## Elkhart County Parks Administration

211 West Lincoln Avenue

01. Parks Dept Parking Lot

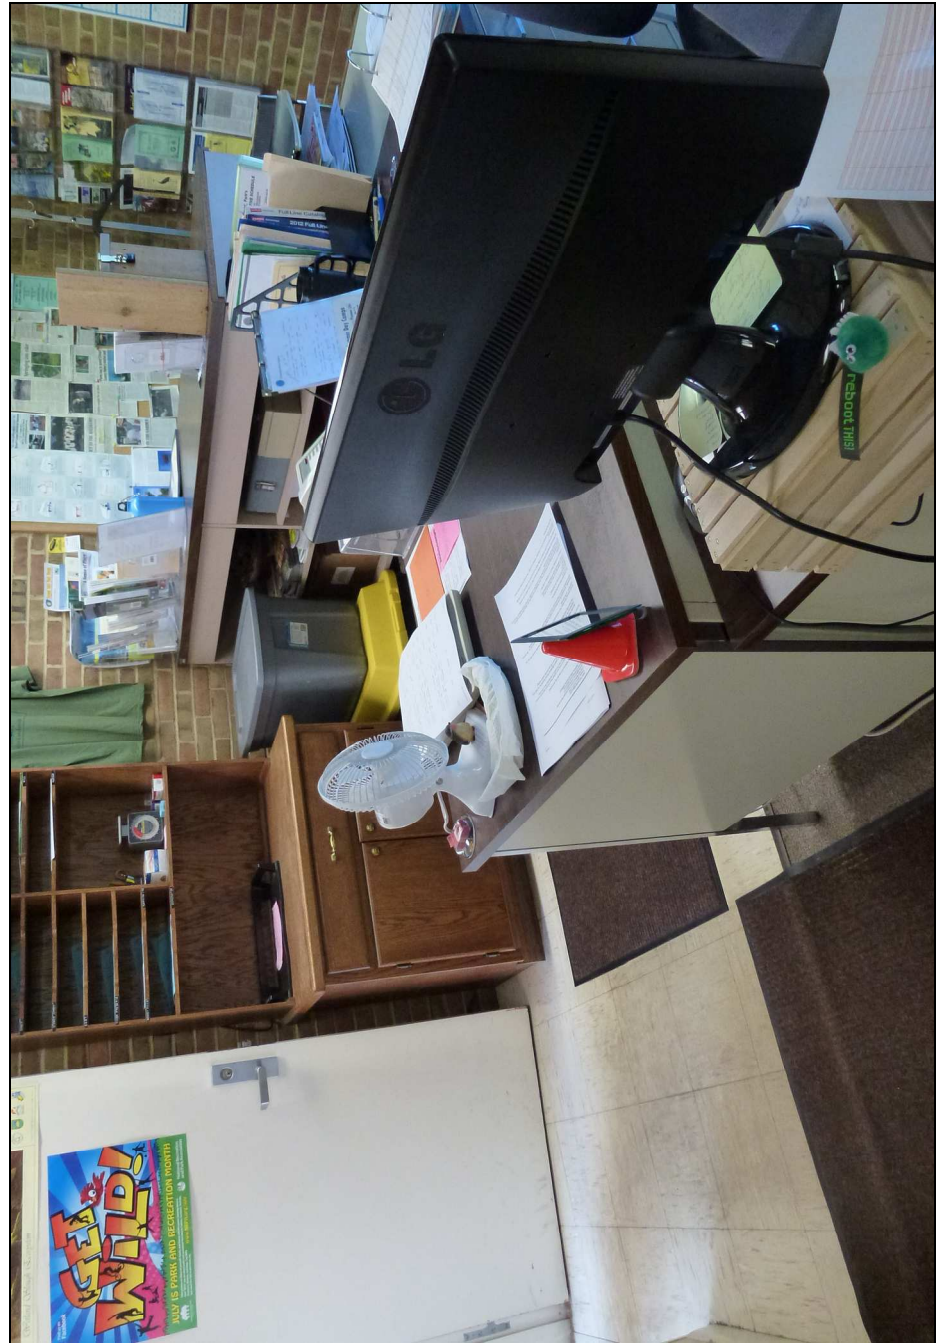
1. Parking	1	No "Van Accessible" sign at van accessible parking space. No enforcement procedure for accessible parking	4.6.4	ADAAG requires accessible parking spaces to be located in each parking lot. Accessible parking spaces are required to have upright signage that includes the symbol of a accessibility and van accessible signage where required. <b>Add one "Van Accessible" sign. Enforce parking regulations.</b>	<b>L</b> : Space is adequate for vans, just no sign posted.	\$50	Elkhart County General Fund	<b>Van accessible sign installed.</b>		<b>Jul-14</b>

03. Parks Dept Rest Room

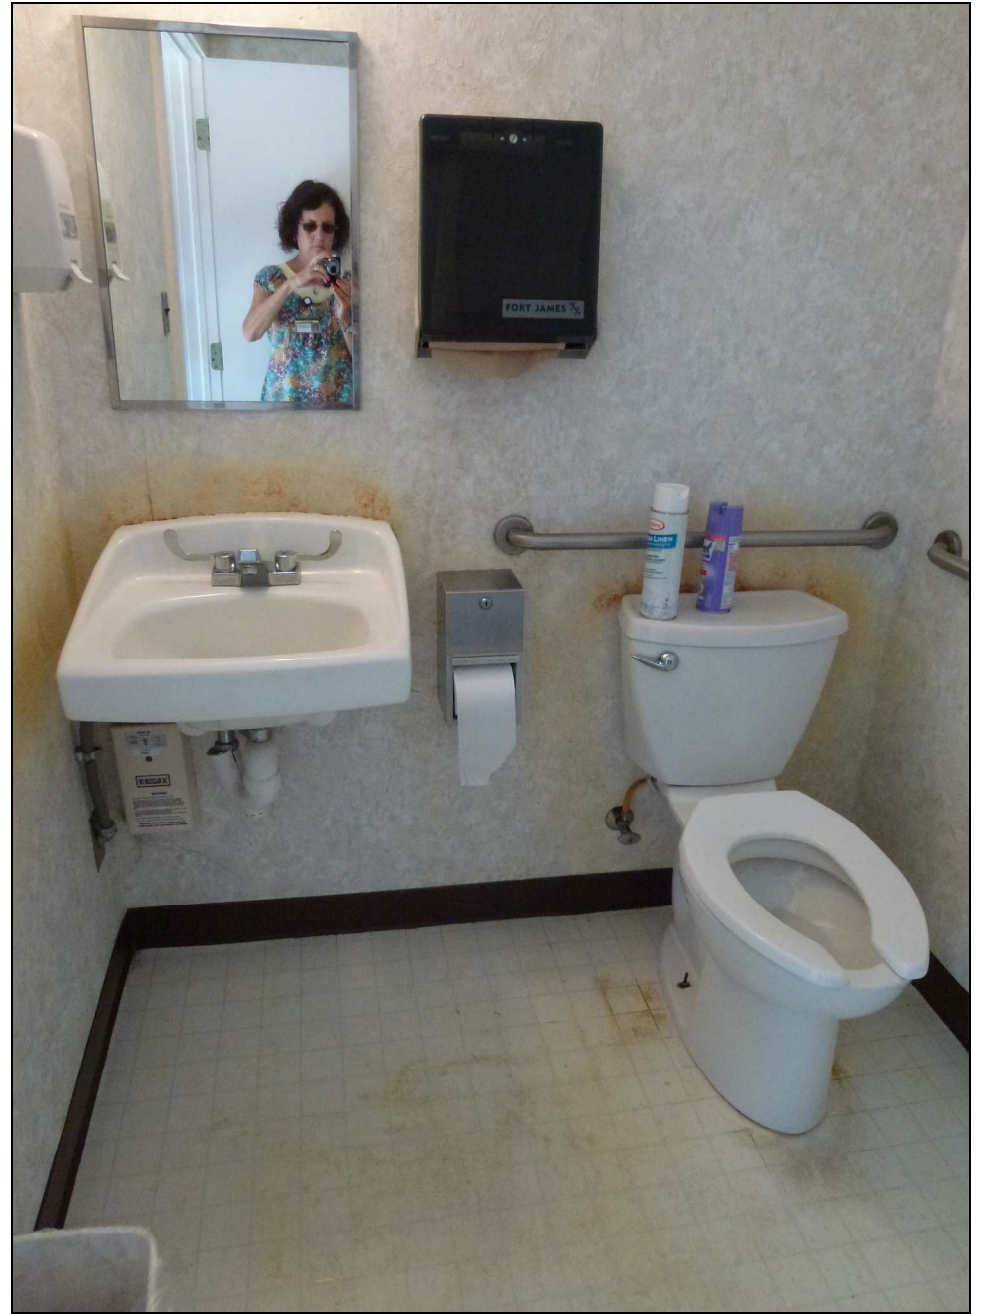
4. Rest Rooms	3	There is no signage provided for the rest room.	4.19.6	ADAAG requires mirrors to be mounted with the bottom edge of the reflecting surface no higher than 40" above finished floor. <b>In this case, this is the only rest room and it is accessible, so a sign is not required, but should be added.</b>	This is not a requirement. No action is needed, but may be helpful.

Location		Structural Inconsistencies		Recommended Corrections/Modifications to Provide Access	Technical Information			Finalized Actions		
Location	Photo	Identified Issue	ADAAG Specification		Priority Ranking and Justification	Improvement Cost	Funding Source	Finalized Correction	Anticipated Date of Completion	Date of Completion
5. Rest Rooms	4	Mirror is mount height exceeds the maximum requirement. The mirror is mounted at 44" from finished floor.	4.19.6	ADAAG requires mirrors to be mounted with the bottom edge of the reflecting surface no higher than 40" above finished floor. <b>Lower the mirror.</b>	<b>M:</b> This could be easily adjusted.	\$50	Elkhart County General Fund	<b>Mirror lowered.</b>		<b>Sep-14</b>
